### **Staff Summary Report**

Development Review Commission Date: 02/12/08 Agenda Item Number: \_\_\_\_\_

Review for 501 WEST FIRST located at 501 West 1<sup>st</sup> Street.

COMMENTS: Request for 501 WEST FIRST (PL070385) (Plan C LLC, property owner; Todd

CONCEPTUAL LANDSCAPE PLAN
50 I WEST FIRST STREET
TEMPE, ARIZONA 17 JANUARY 2008 SCALE: 1"=10"

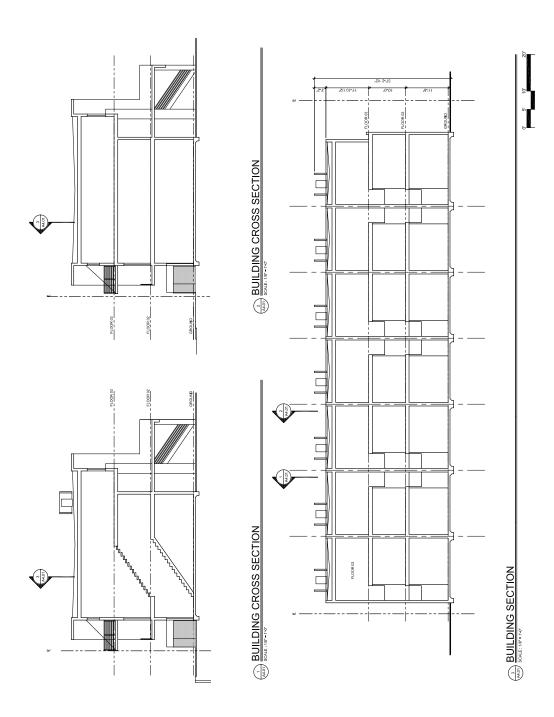
- 24. Comply with the Zoning and Development Code Part 4, Chapter 7, Landscape and Walls.
- 25. The following plants are approved as specified on the landscape plans. Any additions or modifications are subject to review during building plan check process. Planning inspection staff will field verify plants.

- 26. Irrigation notes:
  - a. Place exterior, freestanding reduced pressure and double check backflow assemblies in pre-manufactured, pre-finished, lockable cages (one assembly per cage). If backflow prevention or similar device is for a 3" or greater water line, delete cage and provide a masonry or concrete screen wall following the requirements of Standard Detail T-214.

- b. Provide pipe distribution system of buried rigid (polyvinylchloride), not flexible (polyethylene). Use of schedule 40 PVC mainline and class 315 PVC ½" feeder line is acceptable. Class 200 PVC feeder line may be used for sizes greater than ½" (if any). Provide details of water distribution system.

- c. Locate valve controller in a vandal resistant housing.
  - d. Hardwire power source to controller (a receptacle connection is not allowed).
  - e. Controller valve wire conduit may be exposed if the controller remains in the mechanical yard.

- 27. Top dress planting areas with a rock or decomposed granite application. Provide rock or decomposed granite of 2" uniform thickness or less. Provide pre-emergence weed control application and do not underlay rock or decomposed granite application with plastic.
